Monticello Nuclear Power Station License Renewal Project

**Comparative Evaluation of the Monticello Core Plate Rim Hold-
Down Bolts and BWRVIP-25, Appendix A Analysis**

Response to NRC Question Regarding N2 Nozzle USE Information

Supplemental Information Related to Previous RAIs Responded to on December 7, 2005

Figure 1 Forgings Meet Equivalent Margin Requirements

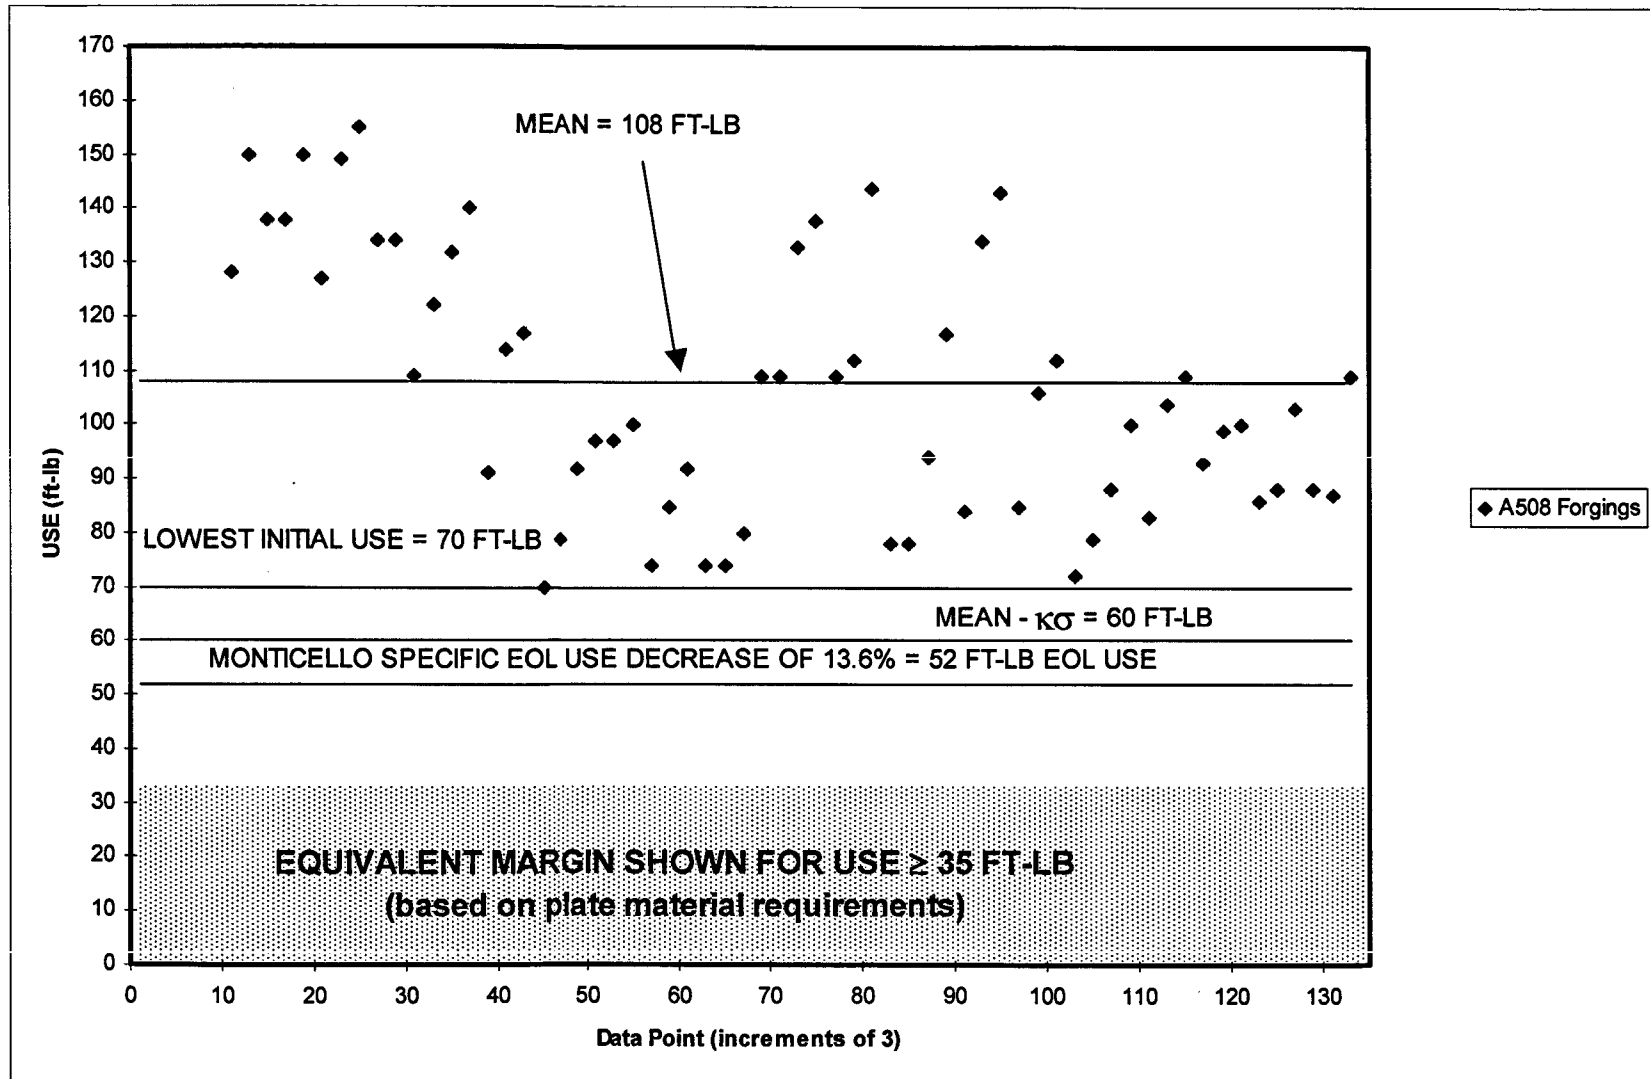
In its initial response to RAI 4.2-3, dated October 28, 2005, the applicant provided a table projecting Upper Shelf Energy (USE) data through the period of extended operation. The staff noted the table was missing data for the nozzles. The applicant referenced BWRVIP-74, which provided USE data for the plates. However, the staff noted that nozzles are forged components, not plates, and requested the applicant to provide a technical basis for their position that the plates are limiting components.

To further demonstrate the acceptability of the N2 nozzle fracture toughness, forging data determined from RVID2 is applied specifically to MNGP. Figure 1 provides the forging data from RVID2 in a manner similar to Figure B-4 of Reference 5. Using Revision 2 of Regulatory Guide 1.99 (RG 1.99) in conjunction with the RVID2 forging database results, the MNGP-specific forging end-of-life (EOL) USE becomes:

MNGP 54 EFPY N2 Fluence	5.23e17 n/cm ²
MNGP N2 %Cu	0.18 (bounds worst case in RVID2 = 0.17)
RG 1.99 Predicted %Decrease	13.6 (using Figure 2 of RG 1.99)
(Mean $- \kappa \sigma$) * (1 - %Decrease/100)	[108 - (1.9996 * 24)] * [1 - 13.6/100]
EOL USE	52 ft-lb

The EOL USE of 52 ft-lb exceeds the transverse plate requirement of 35 ft-lb for equivalent margin.
